IEC TR 60919-1

AMENDMENT 2

Performance of high-voltage direct current (HVDC) systems with line-commutated converters – Part 1: Steady-state conditions

IEC 60919-1:2010-05/AMD2:2017-05(en)

Figure 7 – Bipolar system

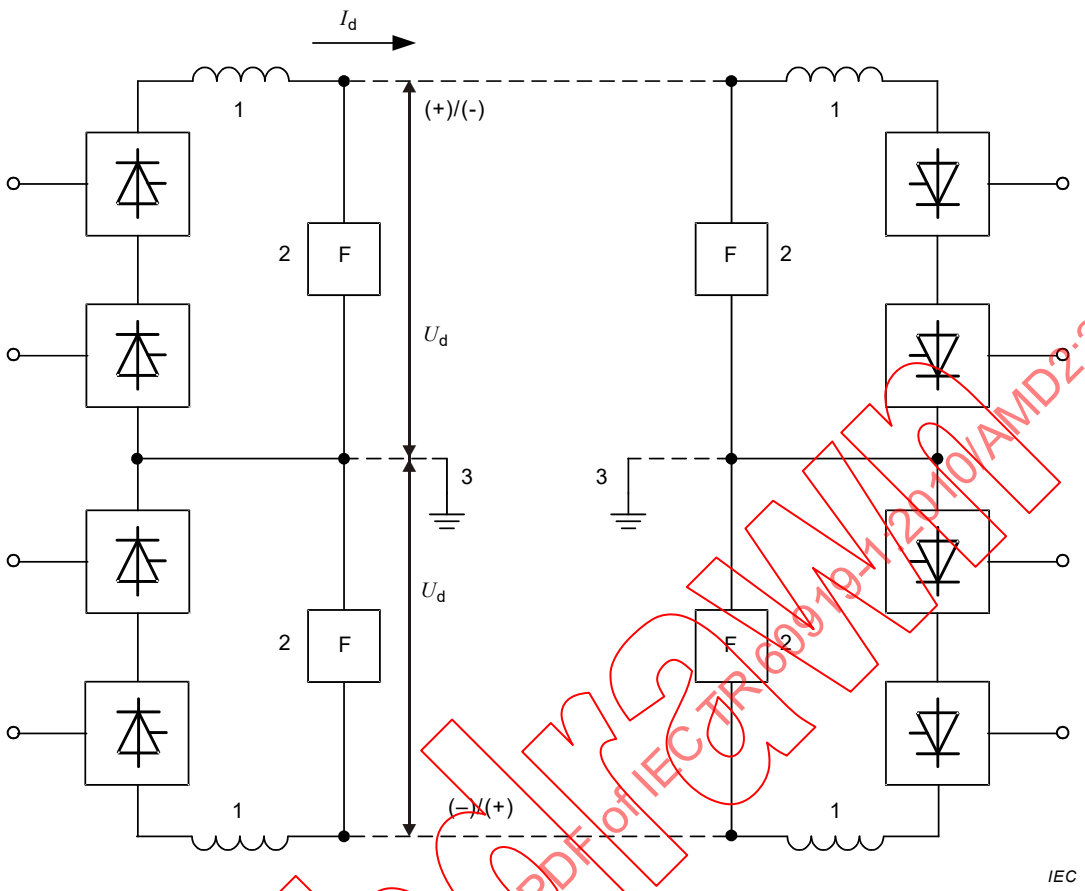
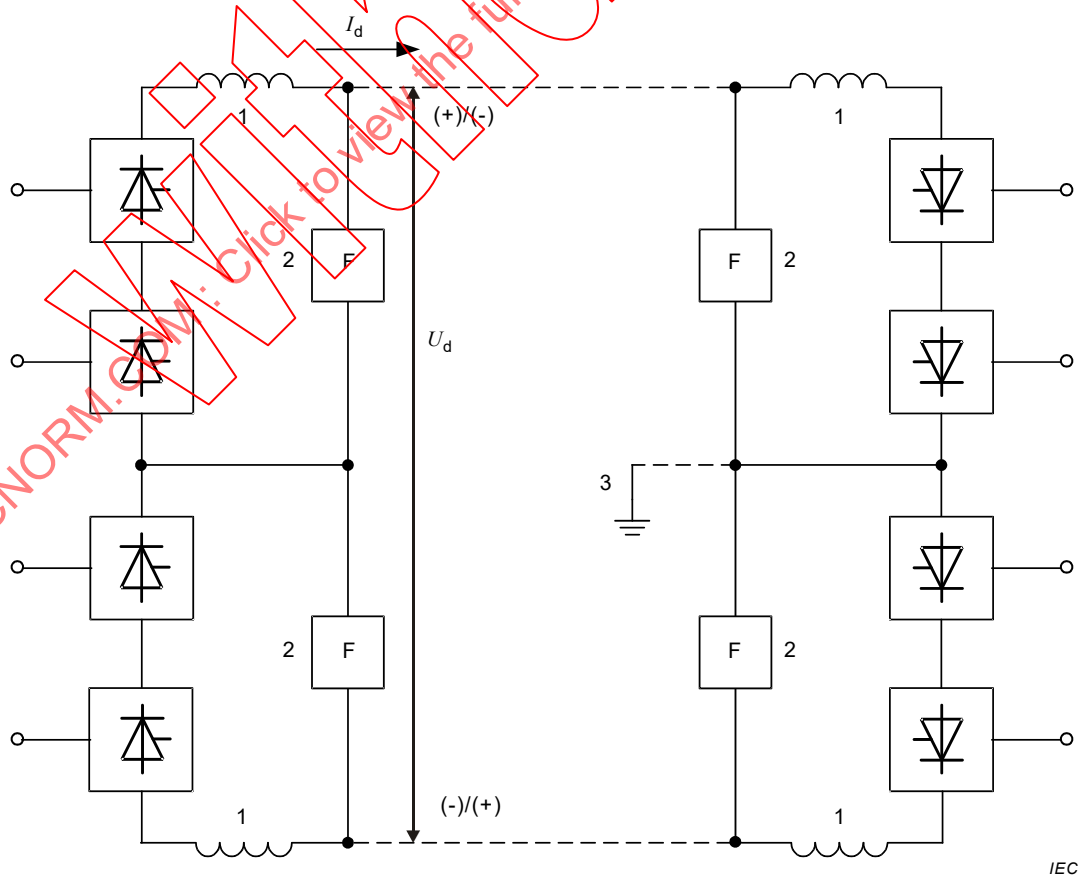
Replace, in the first paragraph, "Figure 7" by "Figure 7 (a)".

Replace the existing Figure 7, modified by IEC TR 60919-1/AMD1:2013, by the following new figure.

Add, after the fourth paragraph, the following new paragraph:

Most of the HVDC system utilises electrode line or metallic return conductor (cable) for d.c. current return path. However, as far as the balanced bipolar operation is always assured, these facilities can be eliminated. This scheme is called "rigid bipole HVDC system" configuration, as shown in Figure 7 (b). With this scheme, operation modes are limited but installation cost can be reduced.

Figure 26 – LCC/VSC hybrid bipolar system

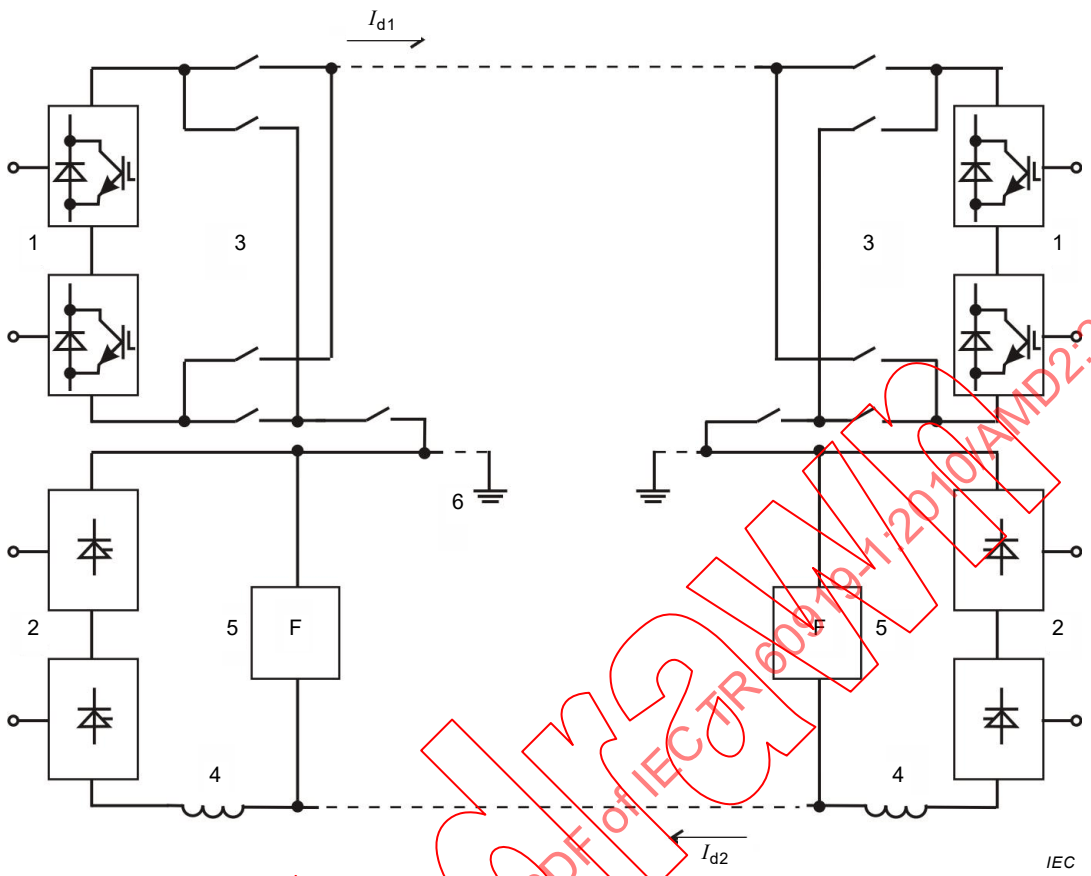
Add, after 3.10, the following new subclause:

3.11 LCC/VSC hybrid bipolar system

In case one pole of LCC is combined with VSC pole, a hybrid bipolar system of LCC and VSC will be formed. For LCC/VSC hybrid bipolar system, special consideration shall be taken because power reversal of VSC system requires current reversal, whereas LCC changes voltage polarity. The combined operation of both systems will lead to excessive current on electrode line or return line for one of the power directions. In order to prevent this problem, switches for polarity reversal should be installed on the VSC converter, as depicted in Figure 26.

Adopted VSC for hybrid system shall be asymmetrical monopole configuration.
